Model: SA11S1, SA15S1, SA8001

Subject: “Can’t Play” is displayed on LCD.

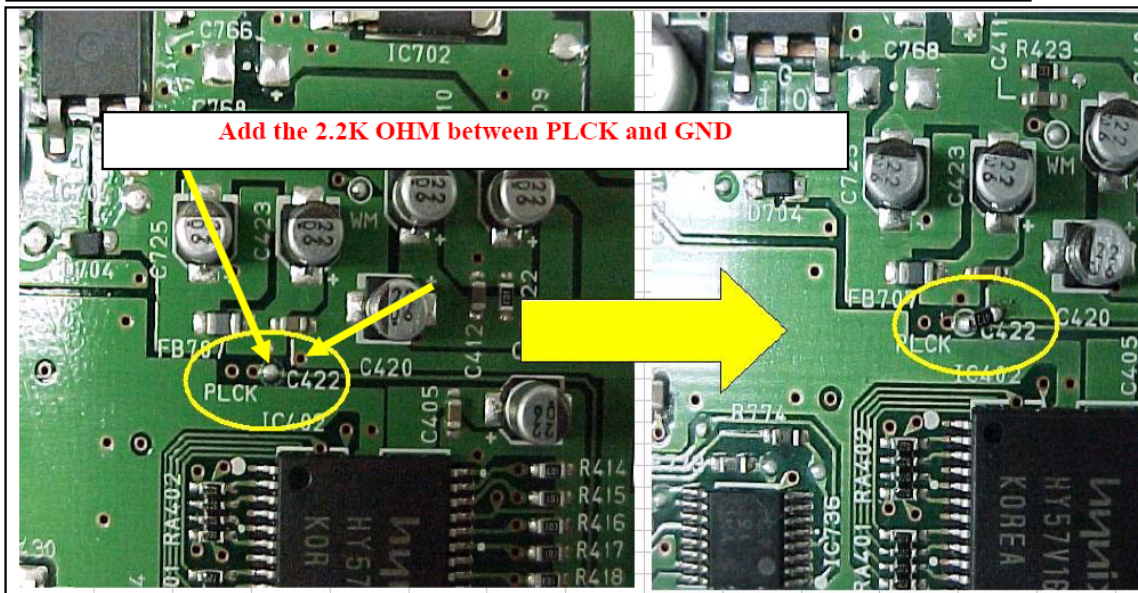
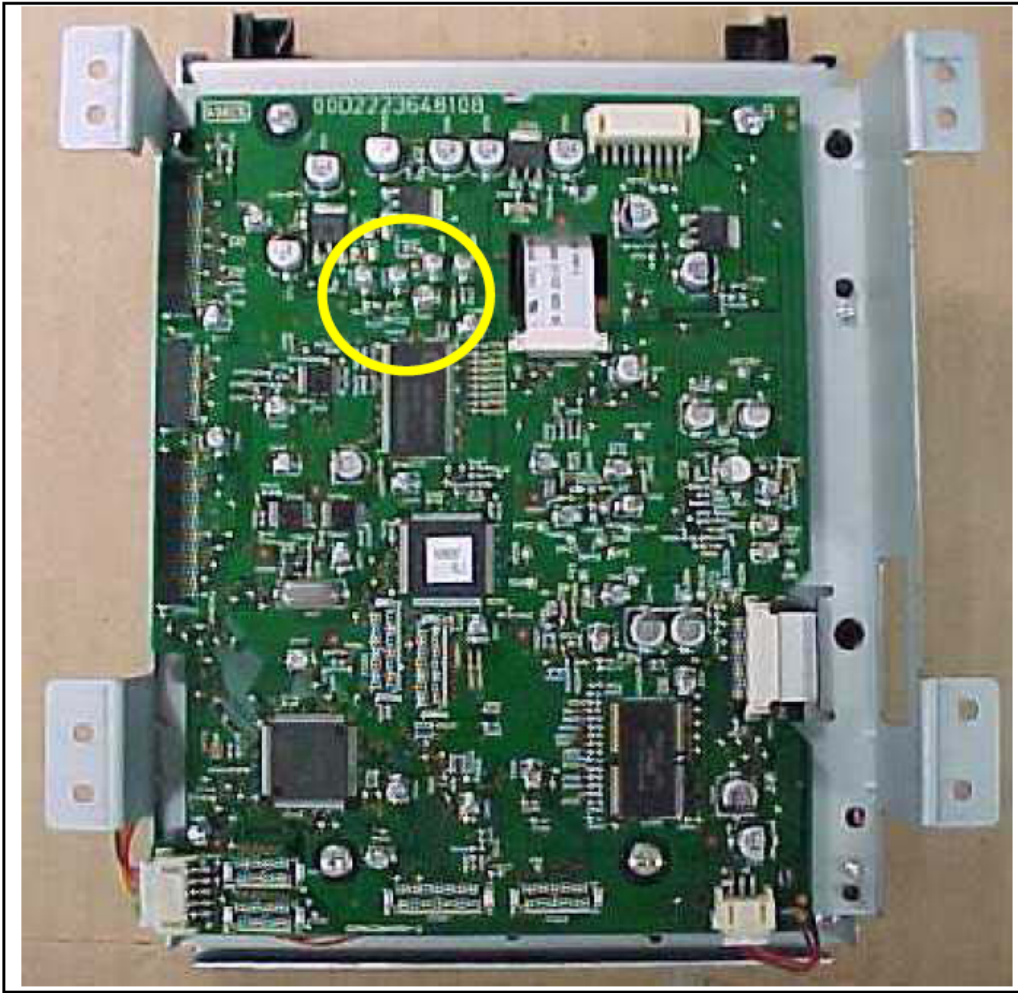
Symptom: During playback a Super Audio CD, “**Can’t Play**” is displayed on LCD.

Solution: Mount 2.2K OHM on the Super Audio CD PWB Module where indicated.

Mount POS.NO. R410 2.2K OHM (PART NO. 00D2472008926) onto the Super Audio CD PWB Module.
